Consists of additional info. concerning
the Overpressurization Mitigating System
for both units of Cook Nuclear Plant....
notorized 11/18/77....w/att drawings.....

Donald C. Cook Nuclear Plant Units 1 & 2
Docket Nos. 50-315 & 50-316
DPR. NO. 58 & CPPR NO. 61.

The purpose of this letter is to provide additional information concerning the Overpressurization Mitigating System for both units of Cook Nuclear Plant.

FIGURE #1

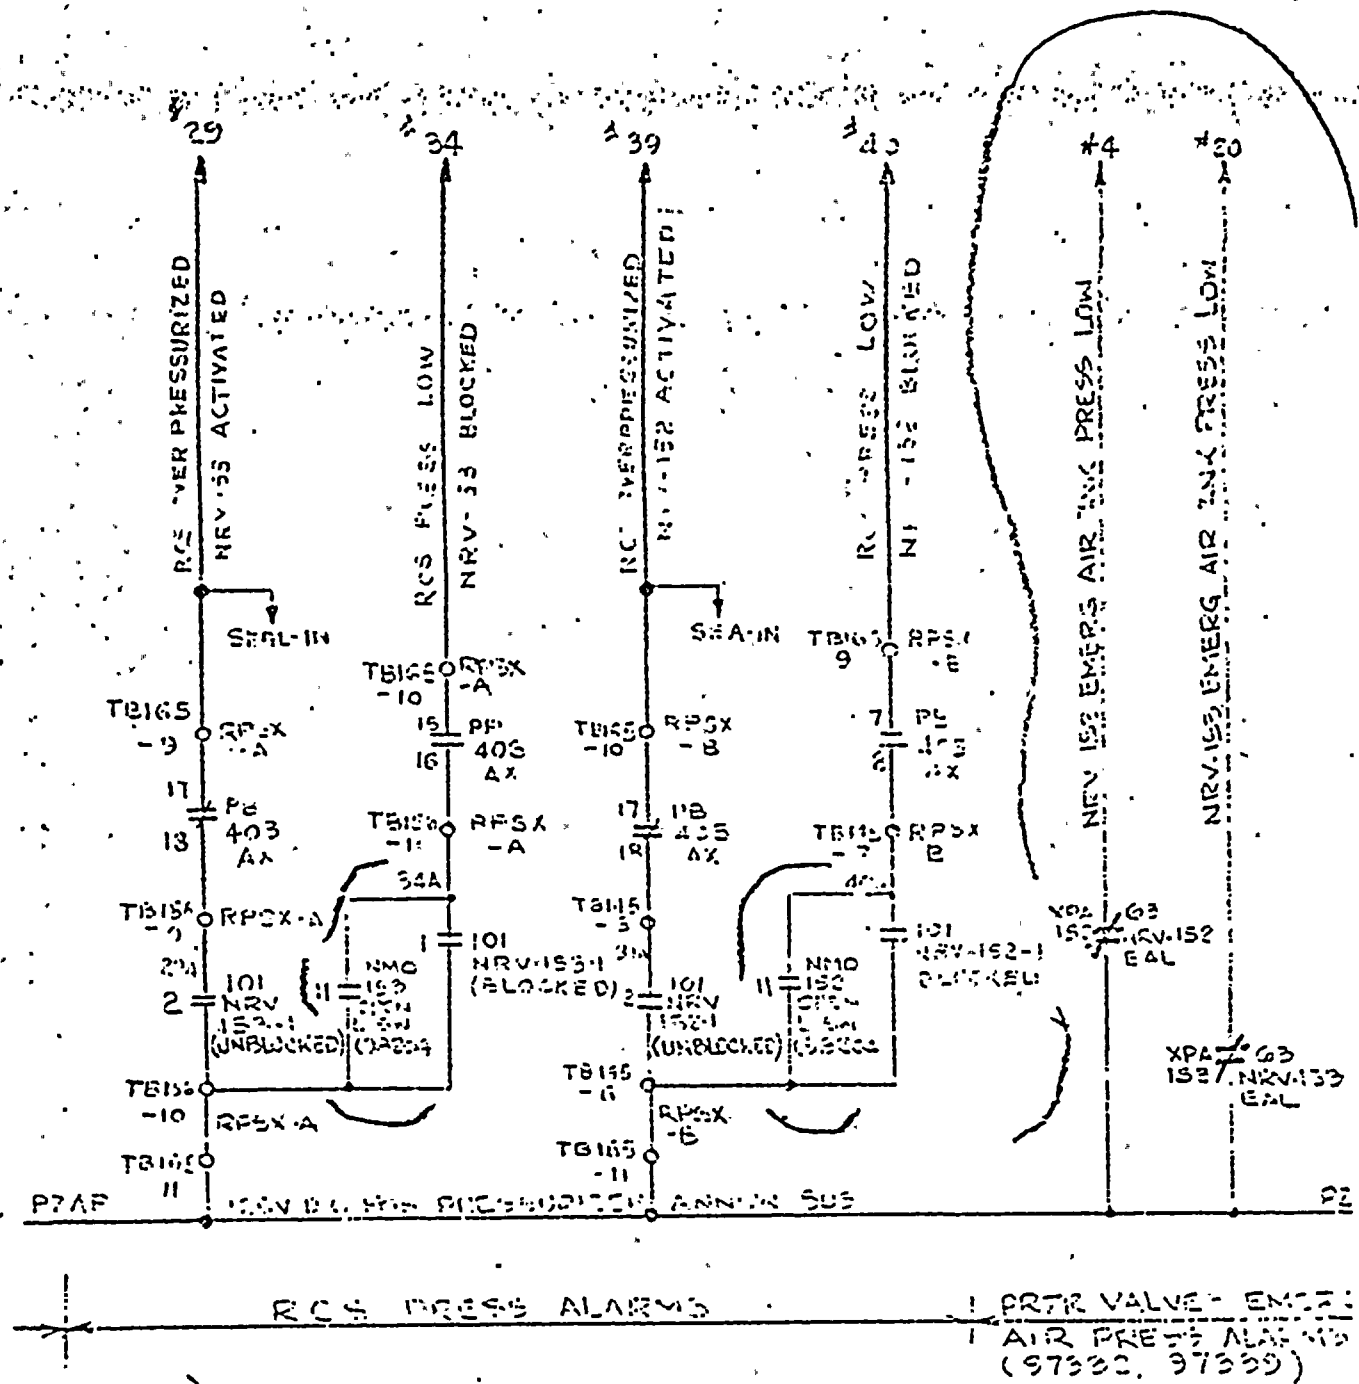
In our letter of August 4, 1977 we indicated, in response to Item No.4, that control room annunciation will be provided for the motor operated valves up-stream of the PORV's to alert the operator if these valves are closed when the mitigating system is enabled. Figure No. 1 provides the revised electrical schematic for the mitigating system annunciators and shows electrical contacts for the "hard-wired" motor operated valve alarms. In addition, this figure shows electrical contacts for a pressure alarm, transmitting to the control room, to alert the operator that the compressed air bottle air pressure is low, as indicated in response to Item 6 of our August 4, 1977 letter. Figure No. 1 is the final version for Overpressurization Mitigating System annunciators and replaces Figure No. 3 of our August 4, 1977 letter.

FIGURE #2

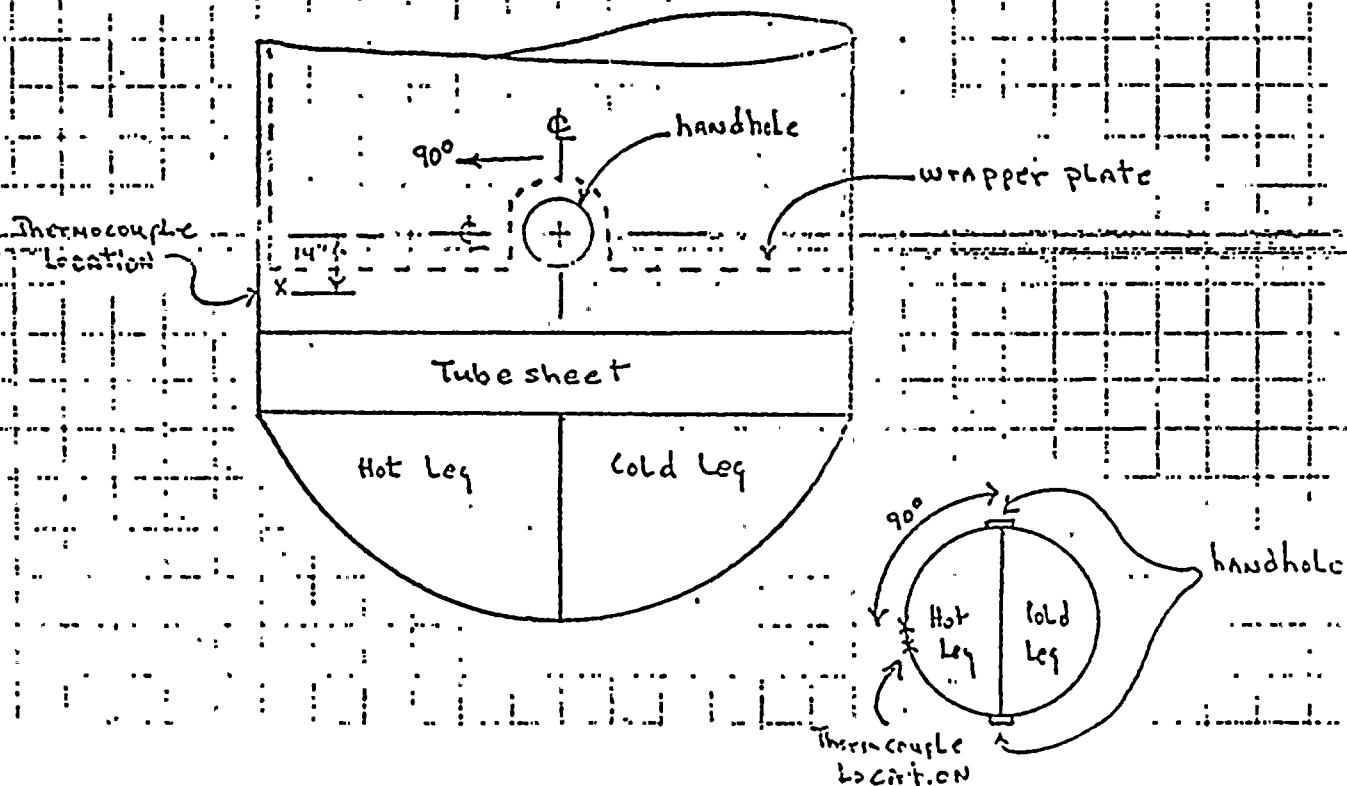
We will be installing surface thermocouples on each steam generator (SG), above the tube sheet, to measure SG shell side temperature. The SG temperature will be shown on a temperature indicator so that the operator can compare SG temperature to the RCS cold leg temperature for the RCS loop in which a Reactor Coolant Pump (RCP) is to be started. Should the SG temperature exceed the RCS temperature by more than 50°F (ΔT) in a loop, the RCP in that loop will not be started up until ΔT is brought within limits ($\Delta T \leq 50^\circ F$). Figure No. 2 shows the thermocouple locations on the SG. In addition, a spare thermocouple will be installed on each SG. We shall include this ΔT limit in our proposed technical specifications for Donald C. Cook Unit 2 and propose the same technical specification for Unit 1 so that it can be available by the time of installation of the OMS in Unit 1.

Two (2) thermocouples are to be located 14" down from the centerline of the hand hole (secondary side). And 90° around the circumference of the steam generator hand hole on the hot leg side. One thermocouple should be on the 90° azimuth and the other located 4" away on either side.

To determine the hot leg side of the steam generator visually check to see which side the hot leg pipe enters. This should be located between the two hand hole plates. Select a hand hole and measure down 14" from its centerline. Keeping a line of 7" in the same plane locate the first probe 90° away from the hand hole on the hot leg side.

Steam Generator Insulation will have to be modified for thermocouple and leads.
